11th and Danville Park Renovation

Details
Other

L-08

1 REINFORCED CONCRETE PAVEMENT (4" THICKNESS)

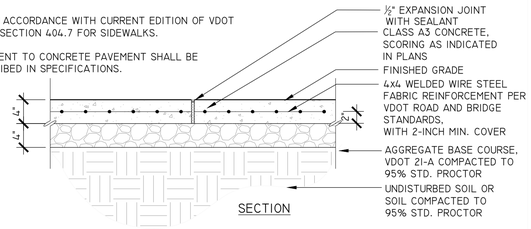
1. Aggregate Sizes 1/2 to ¾ inch nominal. Aggregate shall not contain any red/reddish stone in color. (2022.11.07)
2. ~~Light Cool Gray Basis of Design: Chelmsford Gray granite as manufactured by Carolina Granite Corporation, PO Box 151, Mount Airy, NC 27030, (800) 227-6242, shape as selected by COTR.~~
3. ~~Dark Cool Gray Basis of Design: Chester Gray granite as manufactured by Fletcher Granite, 535 Groton Road, Westford , MA 01886, (978(320-4129, shape as selected by the COTR.~~

N.I.C.
(2022.11.07)

3 BOULDERS ON GRADE

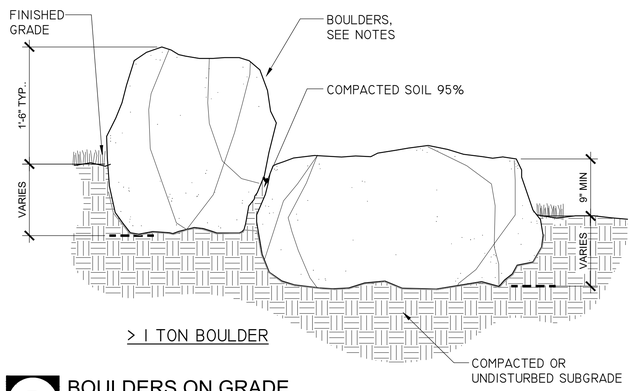
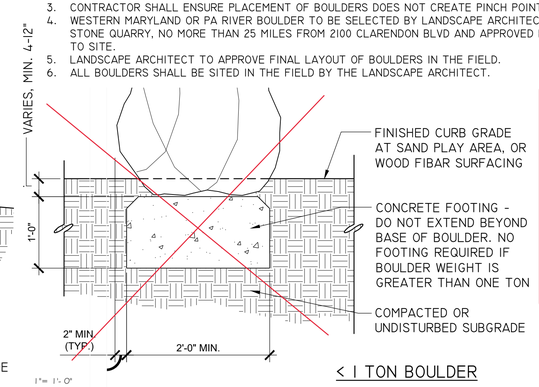
No footer necessary for 11st St Park project regardless of size. Boulder size shall range between 500-1,000 lb.
